<b>Subject:</b>  HARD TO SHIFT INTO 3RD, 4TH, 5TH AND/OR 6TH GEAR	<b>Bulletin No:</b> 05-008/14
	<b>Last Issued:</b> 11/26/2014

## BULLETIN NOTE

- This bulletin supersedes the previous bulletins 05-008/14 issued on 07/14/14. The APPLICABLE MODELS, DESCRIPTION, REPAIR PROCEDURE, and WARRANTY INFORMATION have been revised.
- Changes are noted below beside the change bar in Red.

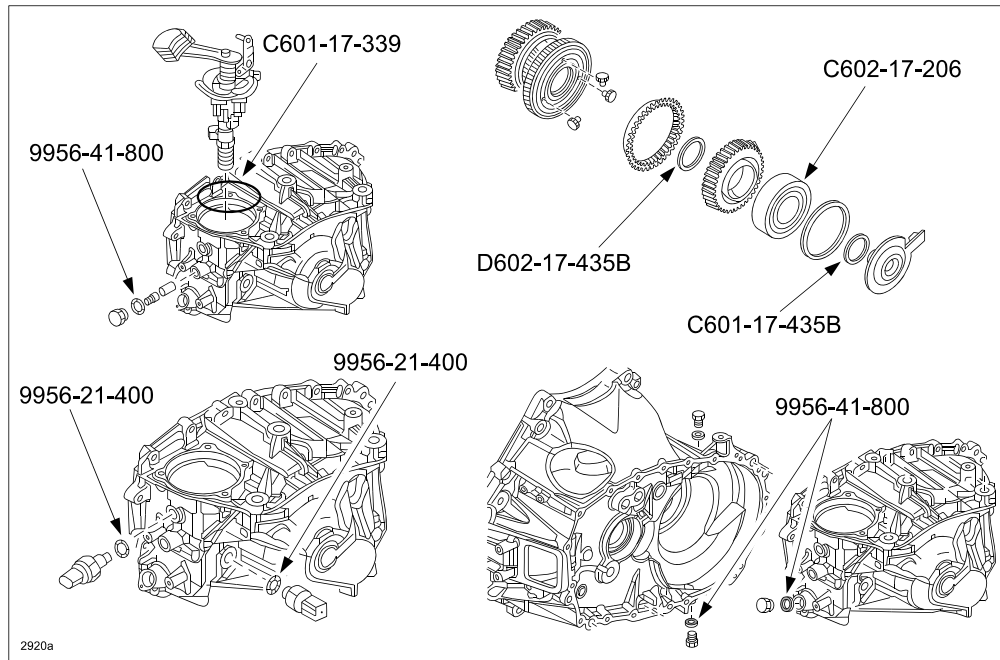
This is caused by a failure of the related clutch hub(s). To correct the problem of hard shifting, the shape of the 3-4 and 5-6 clutch hub has been changed. A surface treatment has now been added to the 3-4 clutch hub to prevent 3rd gear from jumping out.

1. Verify customer concern.
2. Remove the transaxle. Refer to MS3 online instructions or the Workshop Manual section 05-15.
3. Replace the 3-4 and 5-6 clutch hub with a modified one and the 3rd gear with a new one (listed in the Parts Information). Refer to the C66M-R 6-speed SKYACTIV Manual Transaxle Workshop Manual.

- Bearing Puller part number 4907-10-520-L is used for this repair.
  - If 3rd gear is jumping out, replace the 3rd gear with a new one.
4. Install the transaxle.
  5. Verify repair.
